NUREG-0075

STERLING POWER PROJECT NUCLEAR UNIT 1

FINAL ENVIRONMENTAL STATEMENT

U. S. NUCLEAR REGULATORY COMMISSION
OFFICE OF NUCLEAR REACTOR REGULATION

Fig. 2.1. Site layout - Sterling Power Project Unit 1. Source: ER, Fig. 2.5-1, Rev. 2.

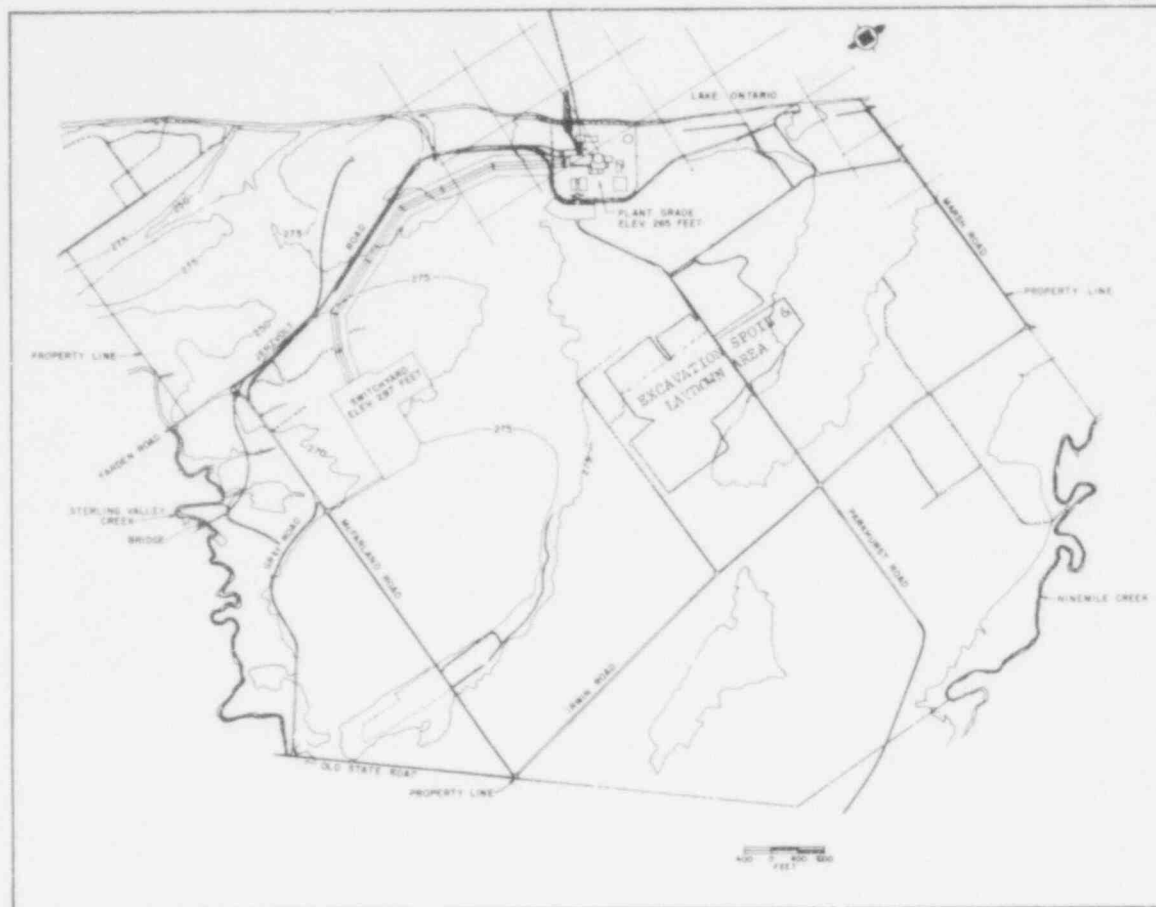
Page 2-3, Figure 2.1

Figure 2.1 adequately describes the proposed plot plan site boundary and roadways. The figure, as drawn, misrepresents the topographic and vegetative features of the site (particularly swamp and wetland boundaries) which are accurately presented in figures 2.7-3 (Inland Aquatic Habitats) and 2.7-15 (General Habitats) of the ER.

Fig. 2.3. Major features of the area within 5- and 10-mile radii of the proposed Sterling Power Project. Source: ER, Figs. 2.2-2 and 2.2-6.

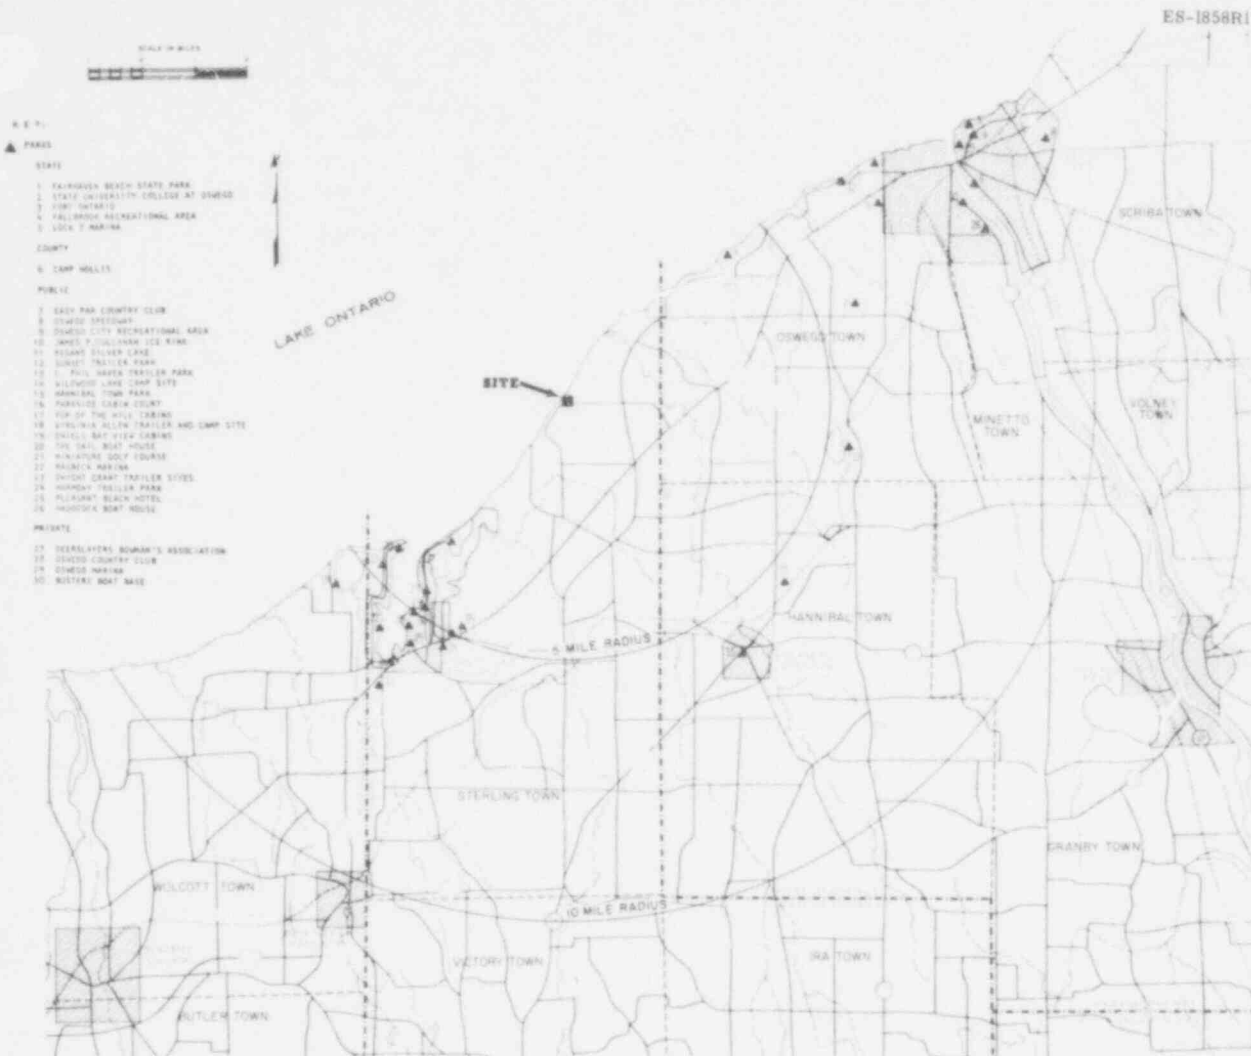
- e. Section 3.9.1 incorrectly refers to Figure 2.3 for information on the railroad.
- f. Section 3.9.2 refers to Figures 2.1 and 2.3 for locations of access roads. These figures do not show access roads.

Land use within 5 miles of the site is shown in Table 11.7. Figure 2.3 has been modified to show recreational areas. Projections of fishing activity for Cayuga and Oswego counties are shown in Table 11.8.

Fig. 3.2. Artist's conception of the proposed Sterling Power Project. Source: ER, Fig. 3.1-2, Rev. 6.

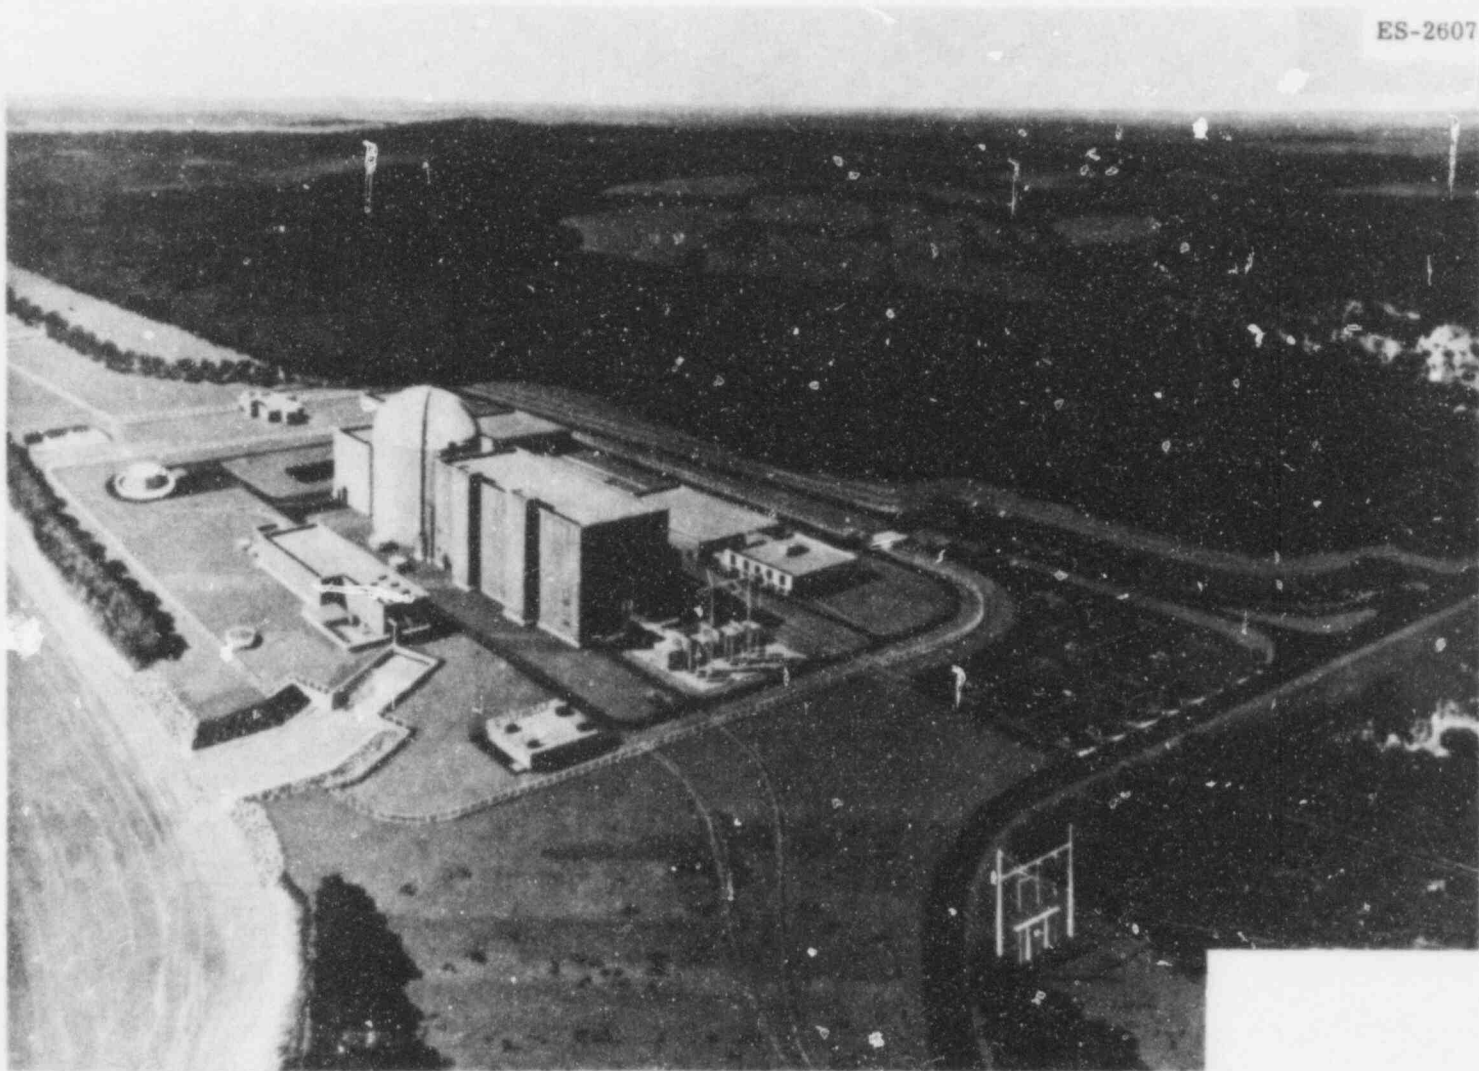
Page 3-3, Figure 3.2

Figure should be updated to ER Figure 3.1-2 (REVISION 6).

Fig. 3.6. Proposed intake structure. Source: ER, Fig. 3.4-3, Rev. 8.

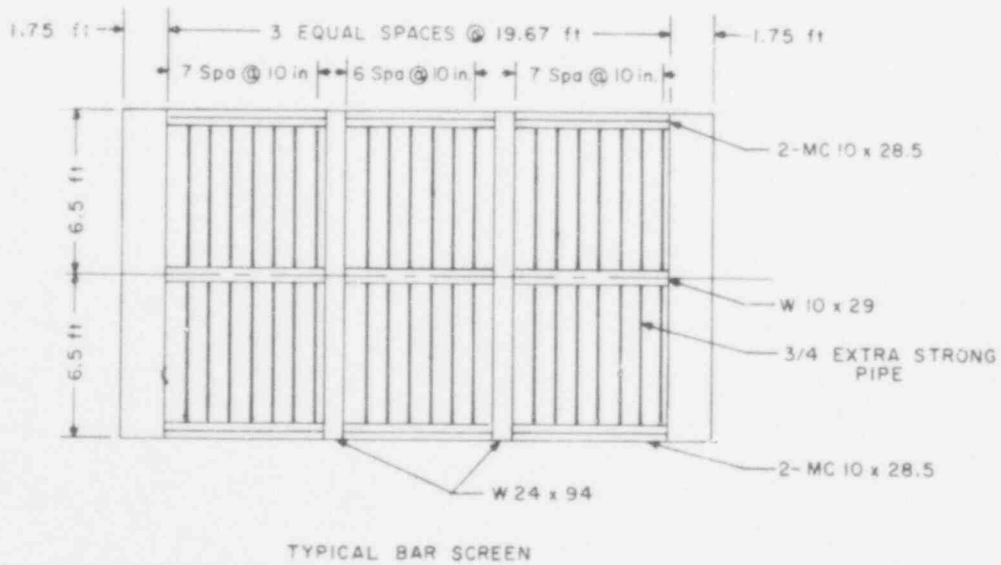
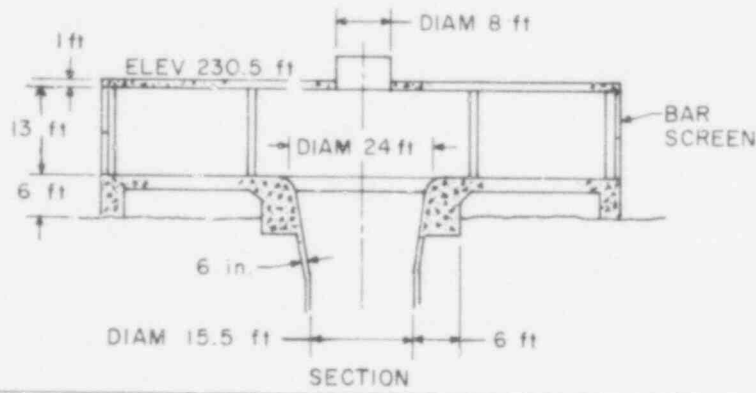
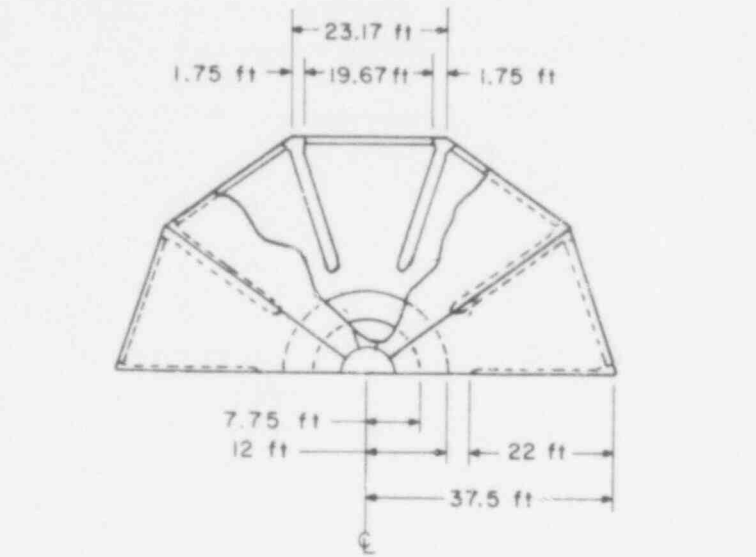
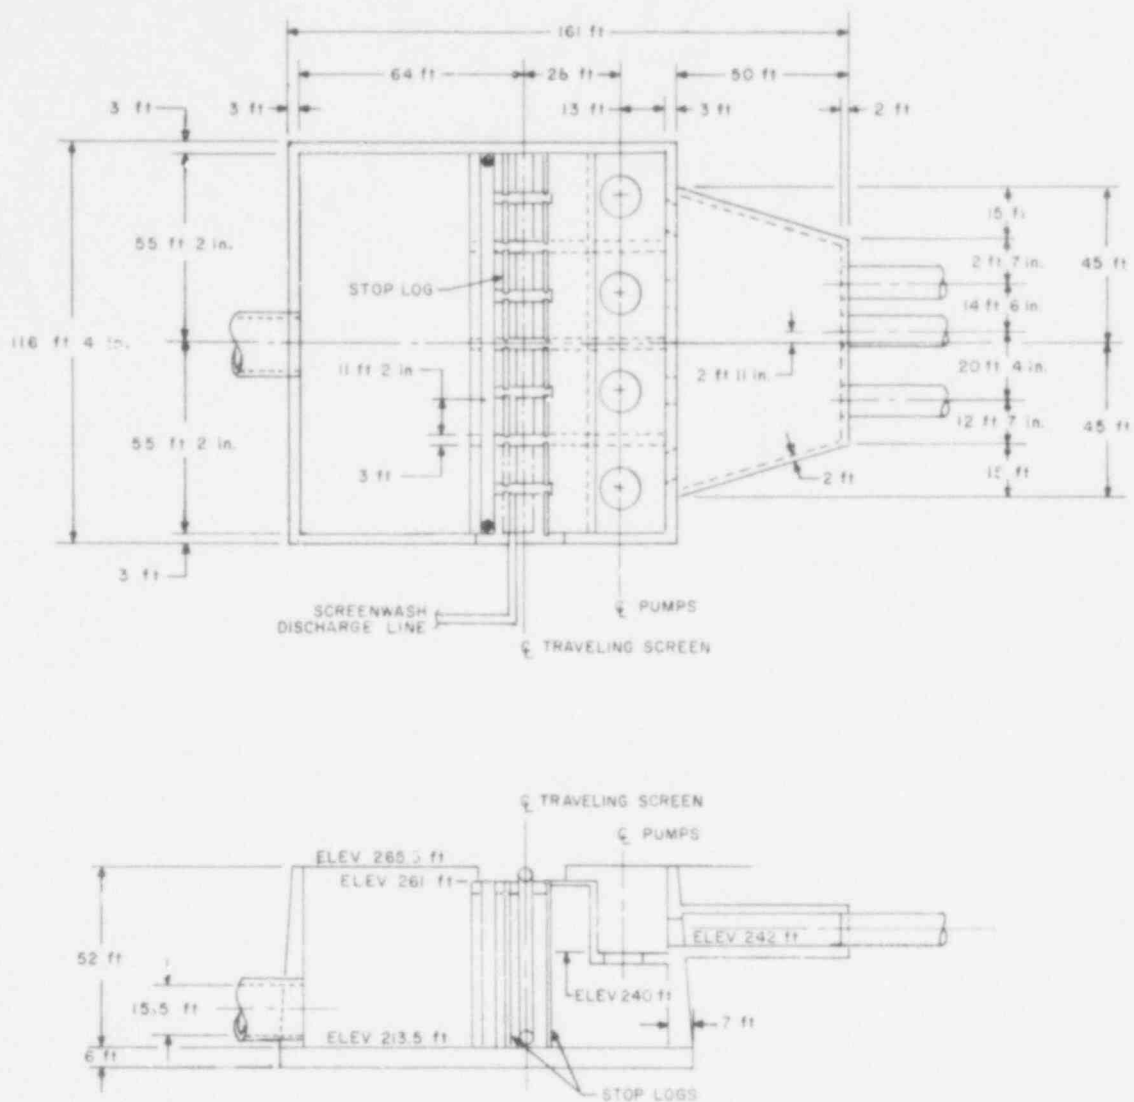
In the text of the Statement, some errors were noted. Captions of the Figures 3.6 and 3.7 should be reversed. In the Figure 3.5, the intake structure is shown above the water level, elevation 276 feet. In the Table C.1, mean depth of Lake Ontario, which is usually defined as volume divided by surface area, should be 283 feet instead of 276 feet. Since volume and depths of a lake depend on the lake level, the table would be improved by adding "below LWD" in the Volume and Depth lines. Low Water Datum for Lake Ontario is 242.8 feet.

Titles and drawings on these figures interchanged. ER Figure 3.4-3 (REVISION 8) should be referred to.

Fig. 4.1. Site map delineating the watershed basins. Source: ER, Fig. 2.7-3, Rev. 1.

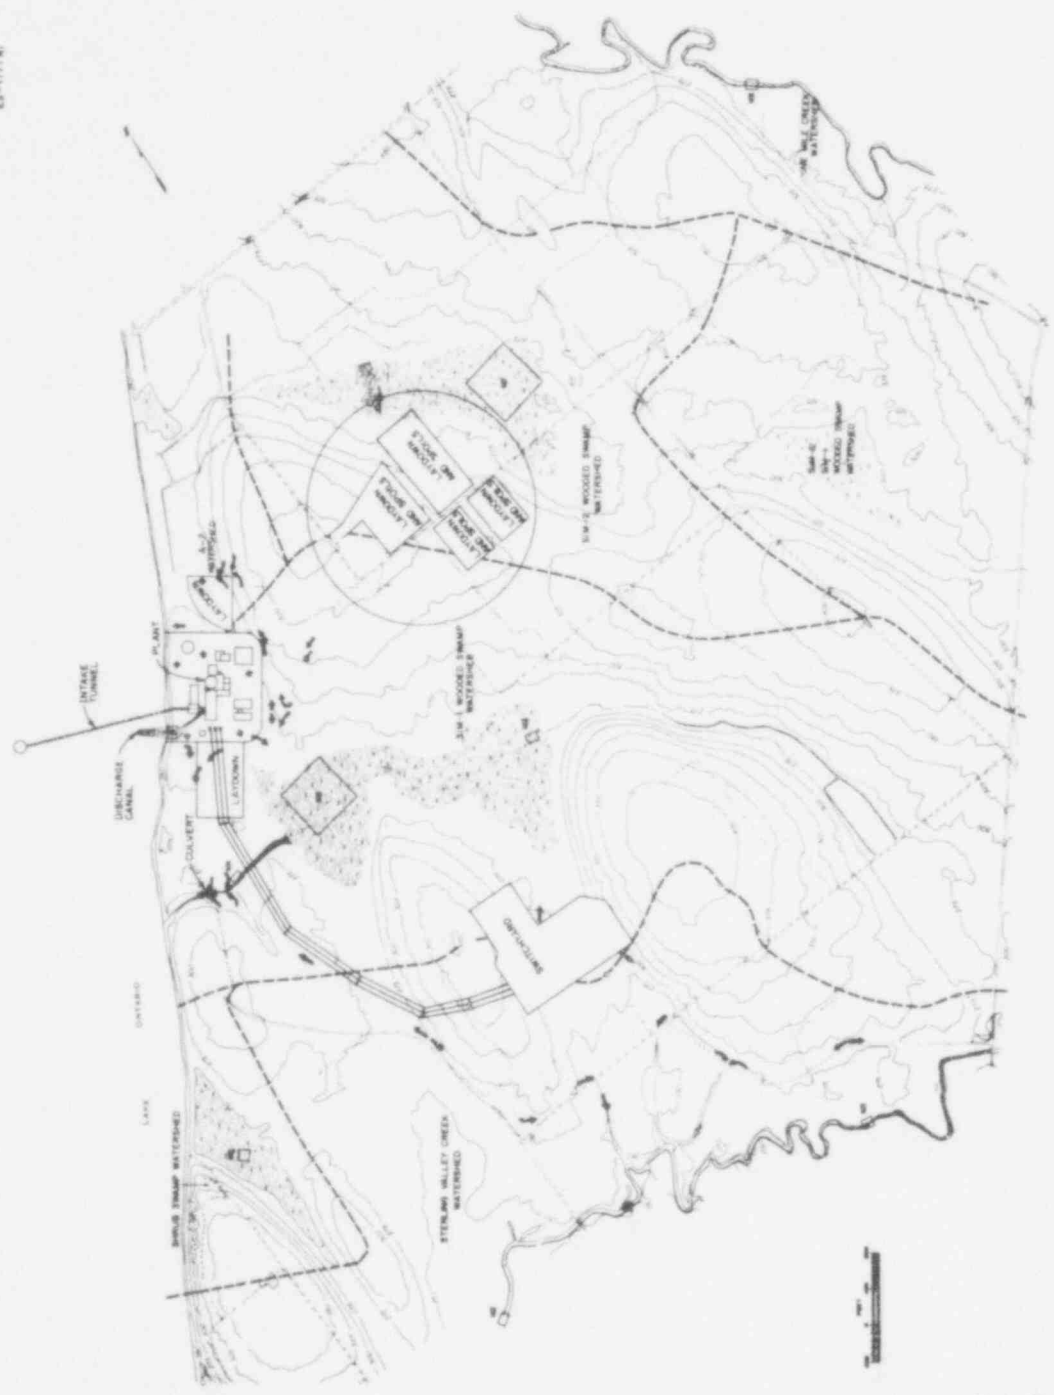
- a. The DES does not discuss shore erosion, shore protection, or the impact of facility construction and operation on littoral drift.
- b. There is no discussion of spoil disposal. The map of the site, Figure 4.1, does not show all of the spoil or laydown areas proposed by the applicant.

Fig. 5.2. Applicant's prediction (NUS II) for lake surface isotherms at Sterling. Lake level = 245 ft (USGS), ambient temperature = 50°F, Froude number = 5.5. Source: 316(a) Demonstration, Appendix 4C, Fig. 24.

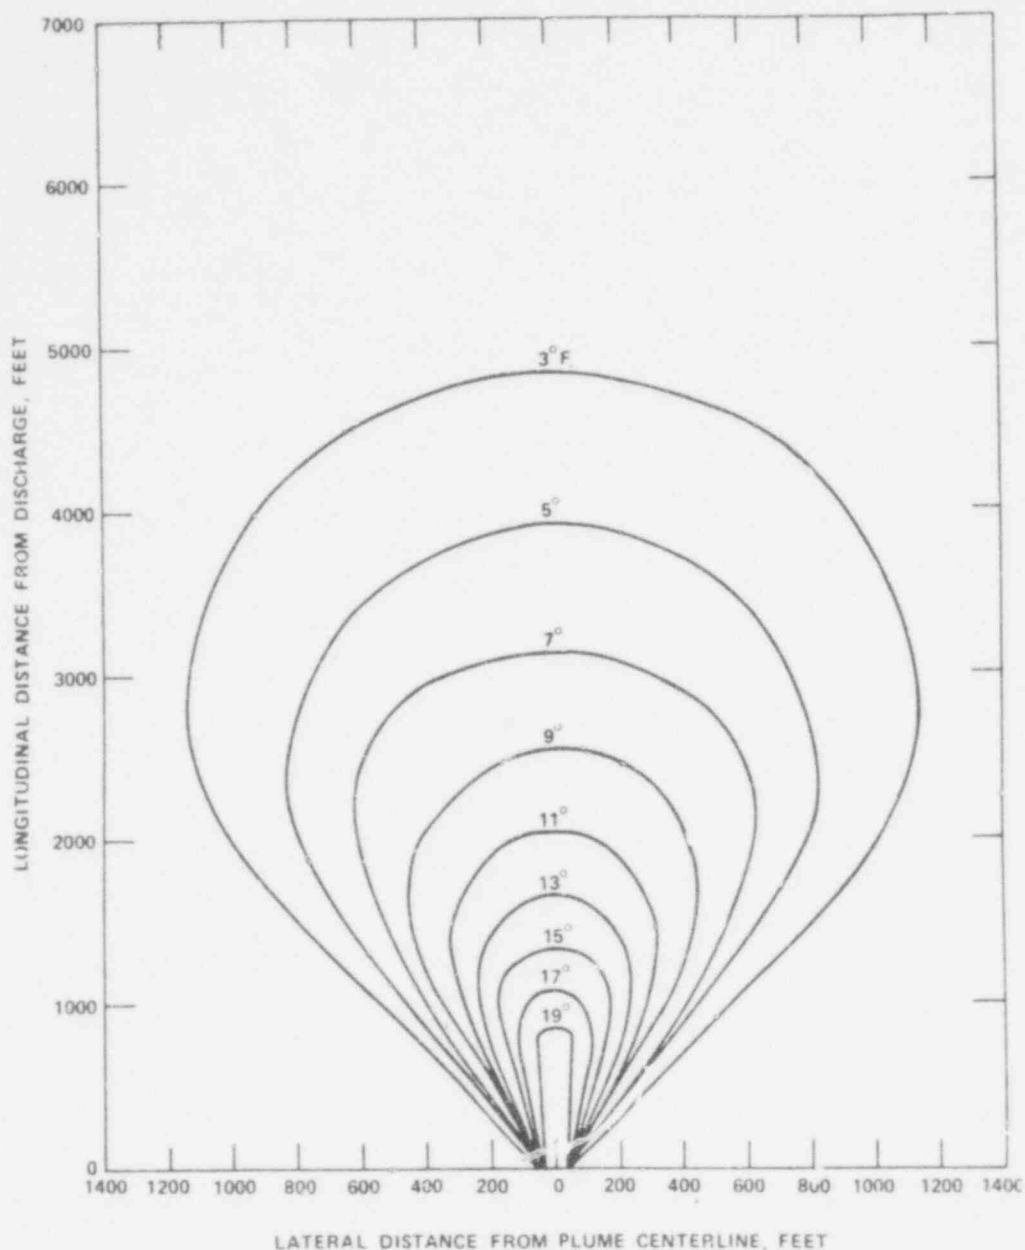
- a. Figure 2.1 of the DES does not use the most current construction site plan. In its most recent proposal, the applicant proposes a shoreline buffer zone, the aesthetic impact of which should be considered.
- b. Figure 4.1 does not include the 77 acre onsite spoils area proposed by applicant.
- c. Acreage figures shown in Table 4.2 are not current and do not agree with the information on Table 4.1
- d. The artist's conception of the project contained in Figure 5.2 is inaccurate. It does not show the proposed discharge canal and retention.
